Product Change Notice

Sept. 15, 2009

PEWs Relationship with Honda Tsushin Kogyo Co., Ltd. And Transfer of some Connector Products

- Inner and outer packaging label

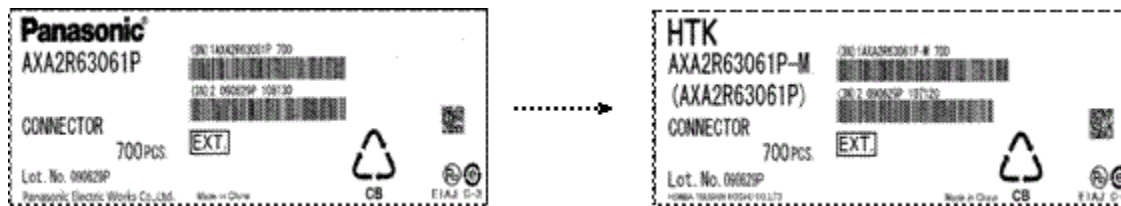
Changes in Specifications and Labels

- **M** is added to all part numbers.

Note: For actual details, Honda Tsushin Kogyo Co., Ltd. specifications should be referred.
